Proposal #17: 4394-03-71
CTH E , CTH FF – Beardsley St
Recreation Trail Bridge & Approach
CTH E
Kewaunee County

This is Addendum No. 01, which provides for the following:

ADDENDUM NO. 01

Addendum No. 01
 ID 4394-03-71
 Revised Sheet 24
 January 10, 2019

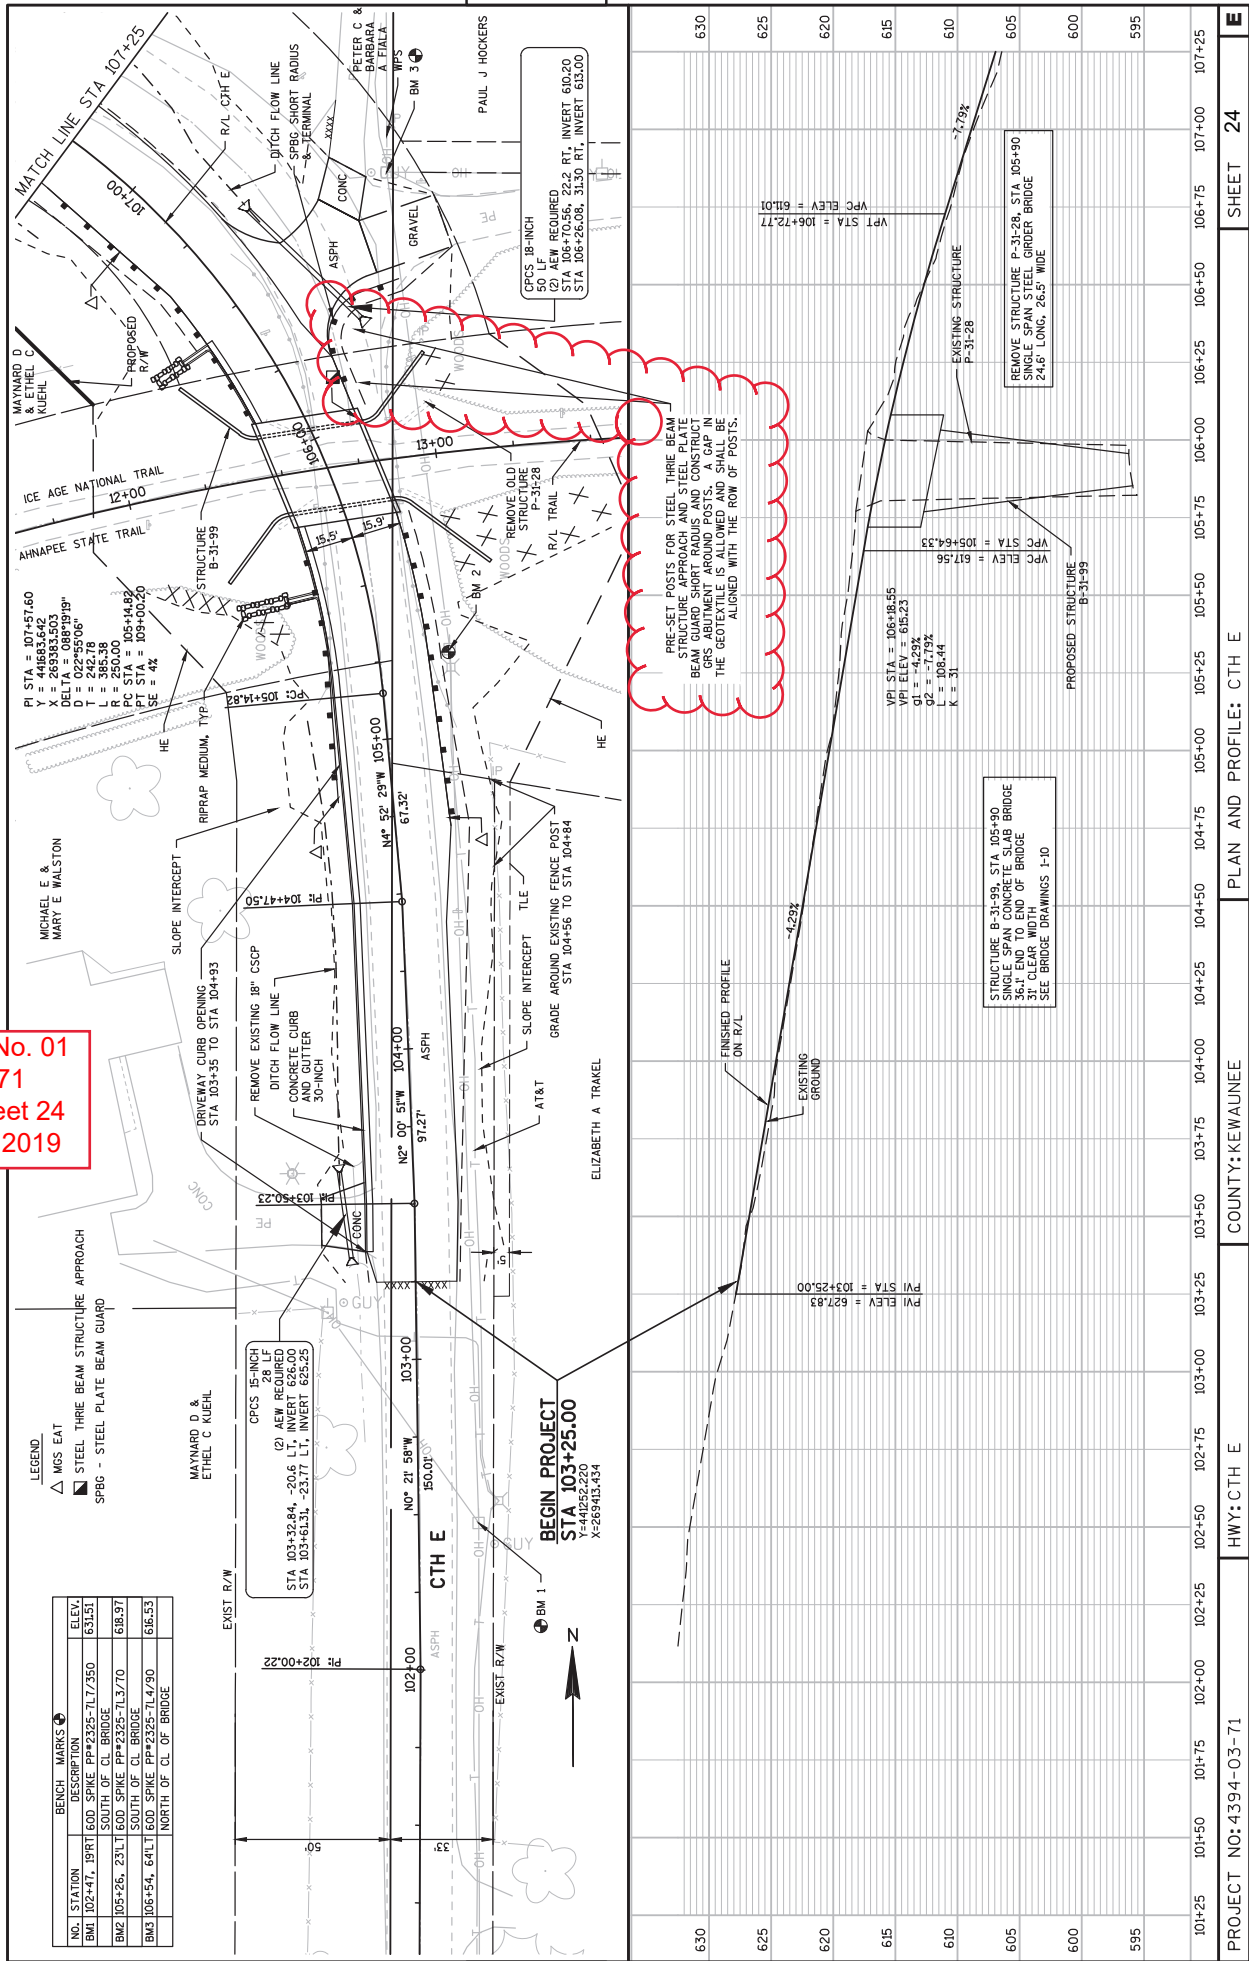
Revised Plan Sheets	
Plan Sheet	Plan Sheet Title (brief description of changes to sheet)
8	Note added to the placement of beam guard posts in the NE Abutment
24	Note added to the placement of beam guard posts in the NE Abutment
